RE: RIVERSTONE HOLDINGS LIMITED - FIORDLAND LINK EXPERIENCE

Riverstone Holdings, Fiordland Link Experience, Civil & Structural Engineering Commentary on Alternative Kiwiburn Terminus

FILE FORBUND LINK EXPERIENCE		MONORAIL	
ALTERNATIVE KIWIBURN TERMINUS			
INDICATIVE SITE PLAN			
SCALE	1:2000 @ A3	DATE	27/01/11 @ 12:18
STATUS	PRELIMINARY	FILE	775460/1
CODE	600038.00	SHEET	50
REVISION		DATE	R2

Figure 1 shows the esplanade reserve which follows – generally – the true left bank of the Mararoa River, and the two extensions of the reserve which meet the Mavora Lakes Road.

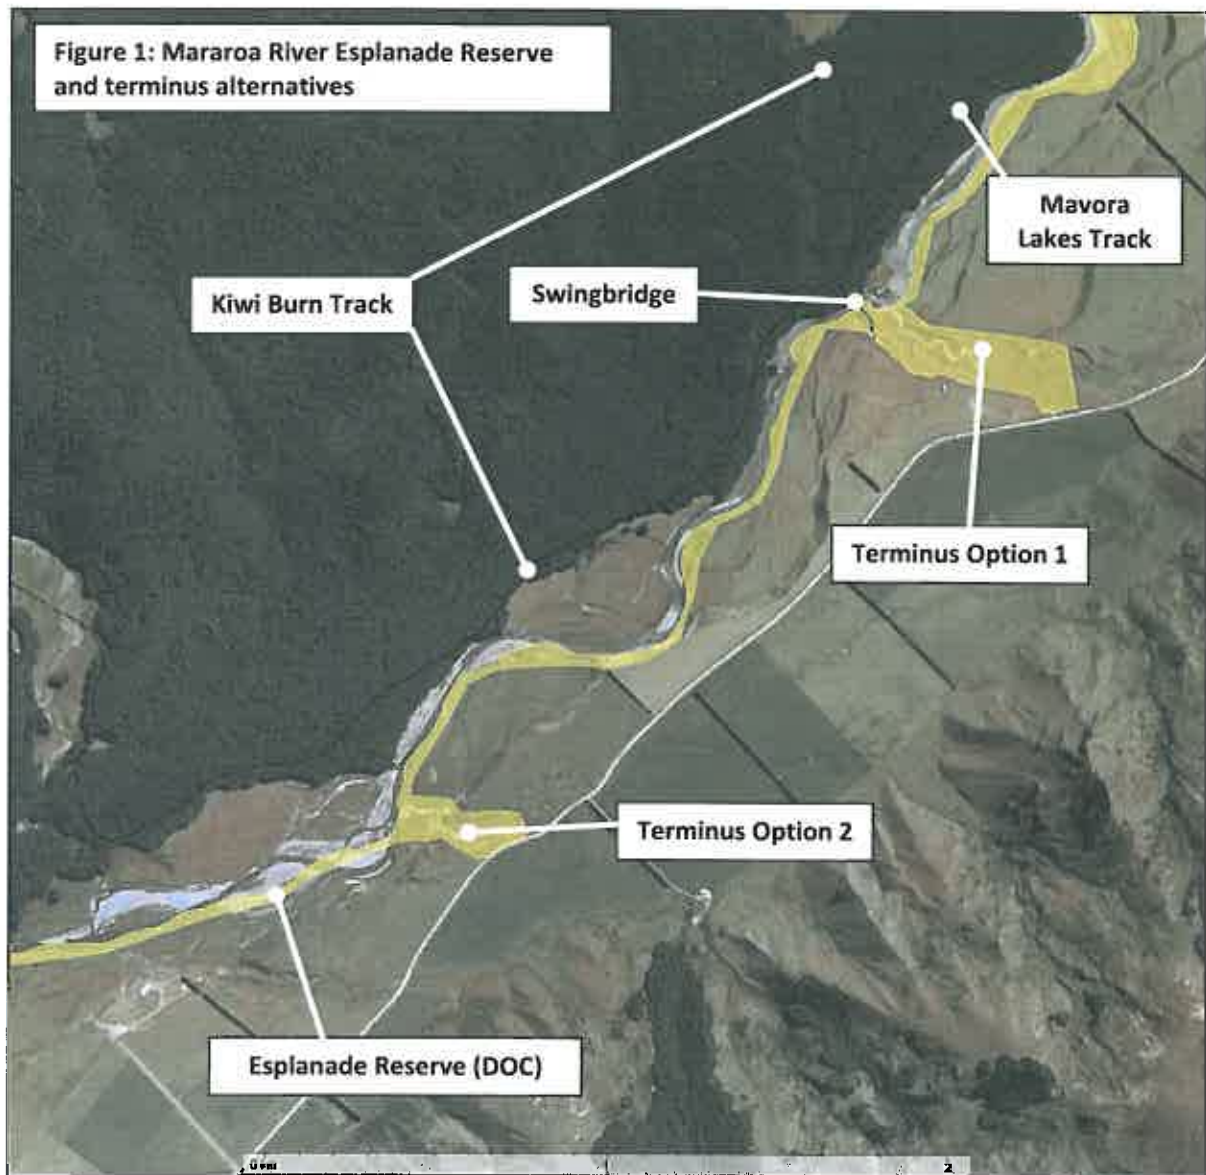
Option 1 in Figure 1 is the proposed location of the eastern monorail terminus as it appears in the FLE consent application. Option 2 is an alternative location for the terminus which has been identified by the Department of Conservation as worthy of consideration.

Option 1 coincides with a section of the Mararoa River which passes over bedrock and provides a section of white water suitable for kayaking. Option 2 is adjacent to an area of gravel bed where the River meanders without any white water features, although it remains kayakable. However, the traditional get-in point is at the southern end of the South Mavora Lake and the get-out is at the swingbridge. Option 2 will therefore avoid the key kayaking section of the Mararoa River. Swimming is assumed to be a potential use at the site of Option 2, although there does not appear to be any significant swimming holes.

Option 2 reduces potential effects on several activities, particularly kayaking and walking, and maintains the local carpark as a dedicated site for casual recreation. The alternative location of the terminus also reduces the length of monorail by approximately 1.7km. This minimises effects on the
